Access Compliance Report

Public Rights-of-Way

Intersection ID: 22787	Main Street: OUTER_BRIDGE_LN	Cross Street: PROVIDENCE_RD	Location: SE
ADA ID: 6AE595E36BE7	Ramp Type: PerpDiag	Initial Pass/Fail: Fail	Overall Compliance: No
			Severity Score: 33.75

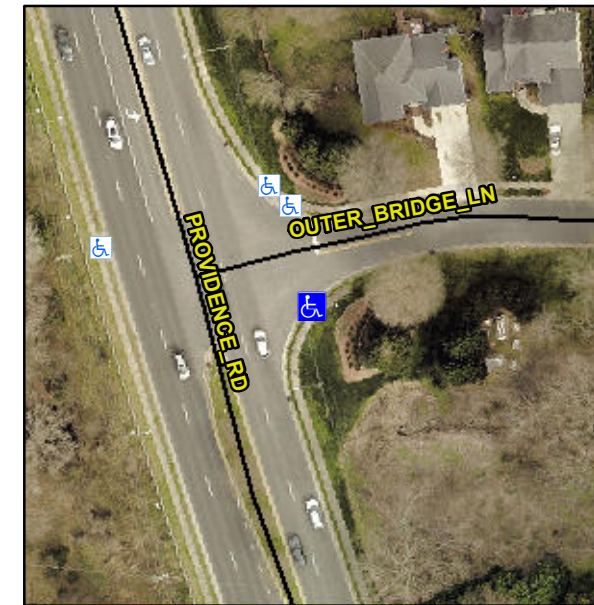
Not Found, R304.5.1, R304.2.2, R304.5.3

Compliance	Description	Data	Compliance	Description	Data
N/A	Ramp Length (in)	72.0	No	Ramp Slope (%)	9.8
No	Ramp Width (in)	46.0	No	Ramp XSlope (%)	5.2
N/A	Flare Type LT	N/A	N/A	Flare Type RT	N/A
N/A	Flare Slope LT (%)	N/A	N/A	Flare Slope RT (%)	N/A
N/A	Flare Traversable LT?	N/A	N/A	Flare Traversable RT?	N/A
N/A	Landing Length (in)	N/A	N/A	DWS Provided?	N/A
N/A	Landing Width (in)	N/A	N/A	DWS Contrast?	N/A
N/A	Landing Slope (%)	N/A	N/A	DWS Length (in)	N/A
N/A	Landing X Slope (%)	N/A	N/A	DWS Full Width?	N/A
N/A	Landing Curb? (Y/N)	N/A	N/A	DWS Offset (in)	N/A
N/A	Shared Landing?	N/A			
N/A	Gutter Ponding?	N/A	N/A	Gutter Slope (%)	N/A
N/A	Gutter Lip Ht (in)	N/A	N/A	Gutter X Slope (%)	N/A
N/A	Painted X Walk1?	No	N/A	Painted X Walk2?	No
	X Walk 1 Direction	To N		X Walk 2 Direction	To W
N/A	X Walk 1 Width (in)	N/A	N/A	X Walk 2 Width (in)	N/A
	X Walk 1 Slope (%)	1.8		X Walk 2 Slope (%)	2.8
	X Walk 1 X Slope (%)	2.9		X Walk 2 X Slope (%)	1.4

Remove & Replace Curb Ramp With Two New Directional Ramps or Equivalent.
